ADDENDUM NO. 1

PROJECT NAME: Old Grissom Road from Grissom to Culebra

DATE: 9/15/2015

TCI PROJECT NO.: 40-00253

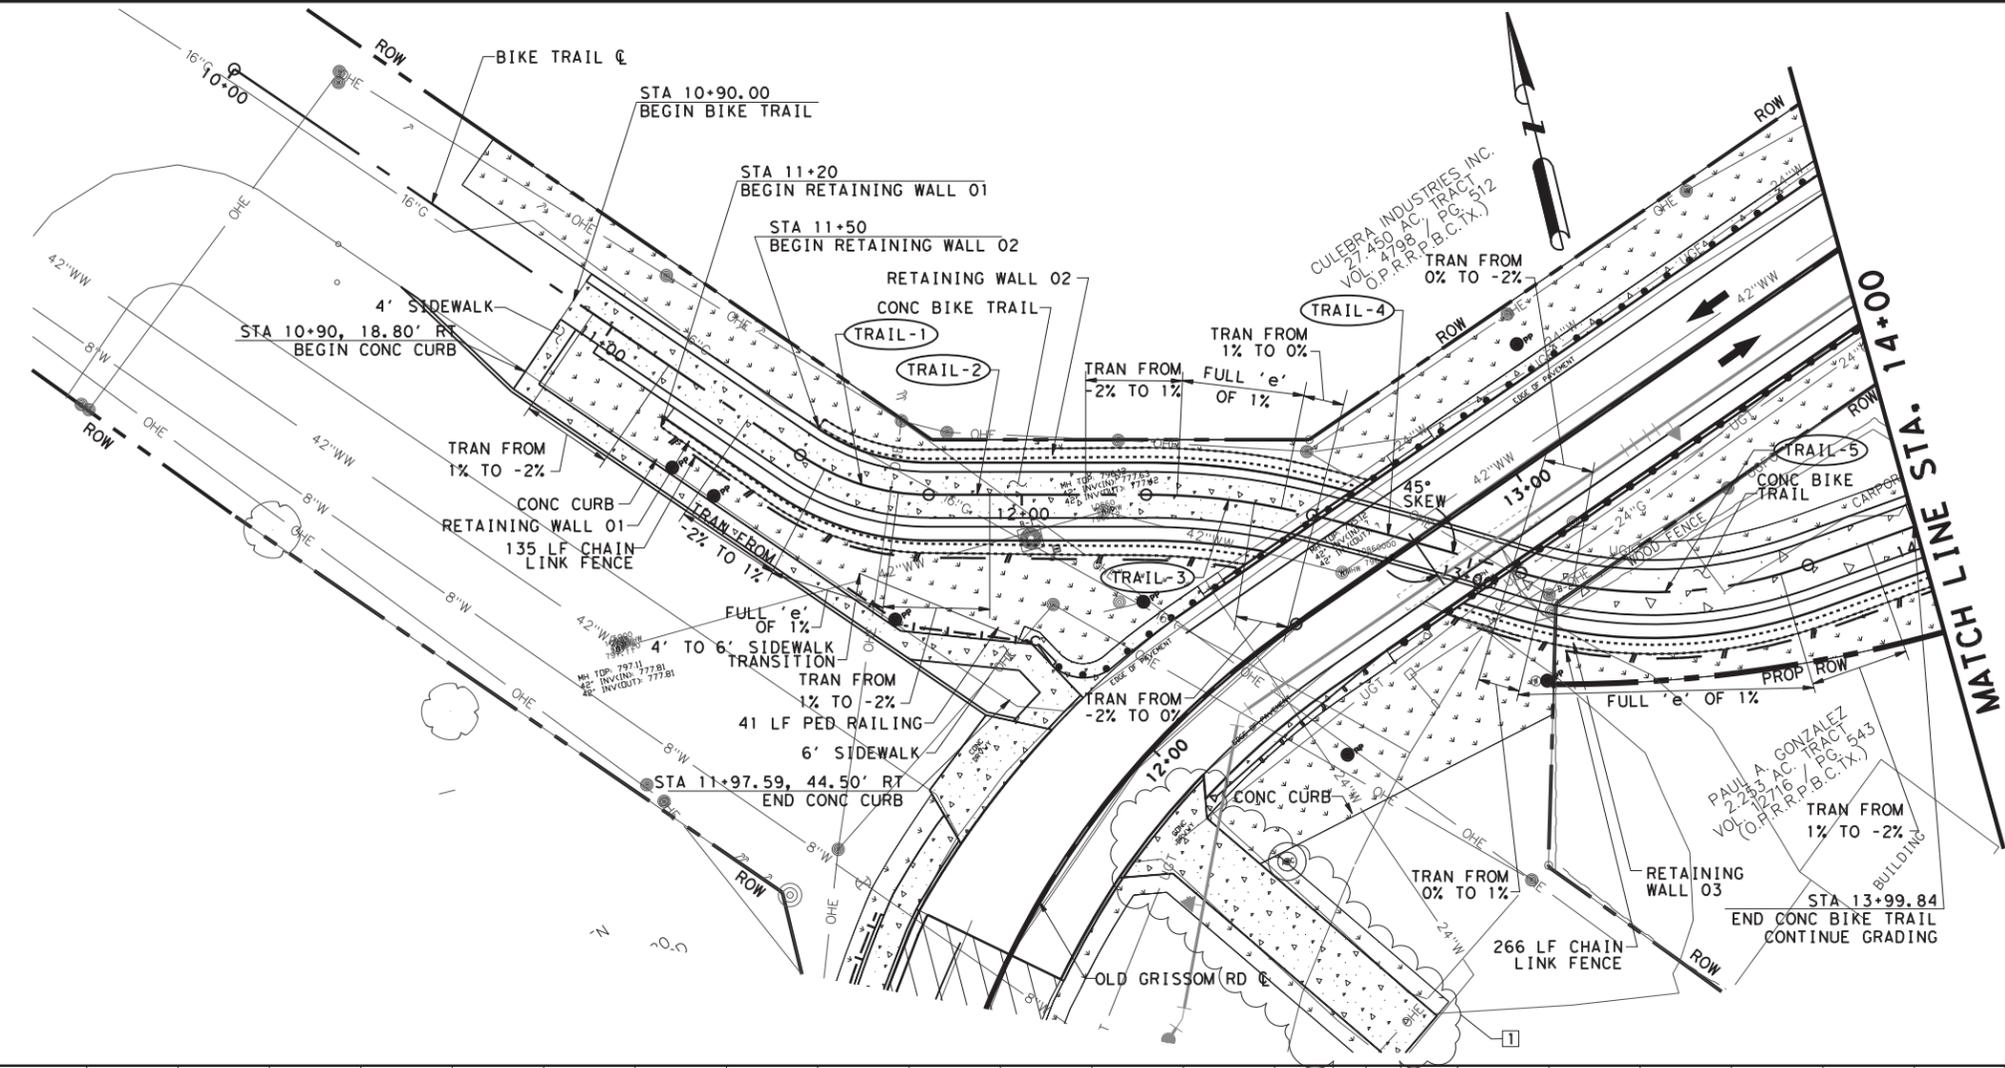
- (1) Pre-Bid Meeting Minutes and sign in sheet from September 10, 2015.**
- (2) Revised 020 Form**
- (3) Remove and replace plan sheet No. 8.** “Additional Notes” added for Soil Policy.
- (4) Remove and replace plan sheet No. 23.** Driveway near Sta. 11+90 on the east side was updated.
- (5) Geotechnical Report and Global Stability Analysis.** Geotechnical Report and Global Stability Analysis added to the Contract.

1. EXCESS SOIL DISPOSAL: CONTRACTOR SHALL PROVIDE A SUBMITTAL REGARDING DISPOSAL SITES TO THE CITY ONCE THE CONTRACTOR RECEIVES THE INTENT OF AWARD LETTER, THE CONDITIONS SET FORTH HEREIN ARE SOLELY DUE TO A DESIRE BY THE CITY TO MANAGE AND DOCUMENT THE DISPOSAL OF EXCESS SOILS FROM THIS SITE IN ACCORDANCE WITH THE CITY'S POLICY. ACCORDINGLY, IN THE SOIL DISPOSAL SUBMITTAL, THE CONTRACTOR SHALL:

- CONTRACTOR SHALL CERTIFY AND ASSURE THAT THE NUMBER OF SOIL DISPOSAL SITES DOES NOT EXCEED THREE (3) SITES.
 - CONTRACTOR SHALL CERTIFY THAT NO DISPOSAL AREAS ARE WITHIN THE FLOODPLAIN AND PROVIDE OWNER EVIDENCE TO THAT EFFECT.

- CONTRACTOR SHALL PROVIDE TO THE CITY OF SAN ANTONIO THE WRITTEN AUTHORIZATION FROM ALL AFFECTED LANDOWNERS TO DISPOSE OF SOIL FROM THIS PROJECT SITE ON THEIR PROPERTY FOR FUTURE DEVELOPMENT.

- CONTRACTOR SHALL INCLUDE PROVISIONS IN LANDOWNER AGREEMENTS THAT THE CITY RESERVES THE RIGHT TO CONDUCT INDEPENDENT VISUAL INSPECTIONS AND SOIL TESTING ON LISTED PROPERTIES, IF NECESSARY PRIOR TO DISPOSAL OF PROJECT EXCESS SOILS TO DETERMINE BACKGROUND LEVELS OF VARIOUS ELEMENTS AS IDENTIFIED BY THE CITY. SAID LANDOWNER AGREEMENTS WILL PROVIDE AN EFFECTIVE RIGHT OF ENTRY THAT WILL EXPIRE UPON SUBSTANTIAL COMPLETION OF THE PROJECT.

- CONTRACTOR AGREES TO ABIDE BY THE LANDOWNER'S WRITTEN CONDITIONS IN LANDOWNER AGREEMENTS INCLUDING THOSE RELATED TO FOR PLACING, COMPACTING, RESTORATION, AND EROSION CONTROL OF THE SITE(S), AND THAT THE LANDOWNERS WILL BE REQUESTED TO PROVIDE FINAL WRITTEN APPROVAL BEFORE PRIOR TO SUBSTANTIAL COMPLETION, AND THAT ANY COSTS THAT THE CITY INCURS TO ADDRESS LEGITIMATE LANDOWNER CONCERNS WILL BE CONSIDERED AND MAY BE DEDUCTED FROM THE CONTRACTOR'S FINAL PAYMENT AS DETERMINED BY THE CITY.

- CONTRACTOR AGREES TO COMPLY WITH OTHER REGULATORY AUTHORIZATIONS FOR PROPER AND LEGAL IMPLEMENTATION OF TEH REUSE PLAN PRIOR TO SOIL TRANSPORT, AS APPLICABLE, CONTRACTOR NEEDS TO ENSURE AND APPROPRIATE A STORM WATER POLLUTION PREVENTION PLAN DEVELOPED AND IMPLEMENTED IN ACCORDANCE WITH THE TEXAS POLLUTANT DISCHARGE ELIMINATION SYSTEM REQUIREMENTS, AS APPLICABLE.

- CONTRACTOR SHALL BE RESPONSIBLE FOR TRACKING EXCESS SOIL DISPOSED OF AT APPROVED DESIGNATED AREAS. CONTRACTOR SHALL TRACK LOADS AND PROVIDE DOCUMENTATION, SUCH AS TRIP TICKETS OR "BILL OF LADING" FOR ALL TRANSPORTED TO EACH APPROVED SITE.
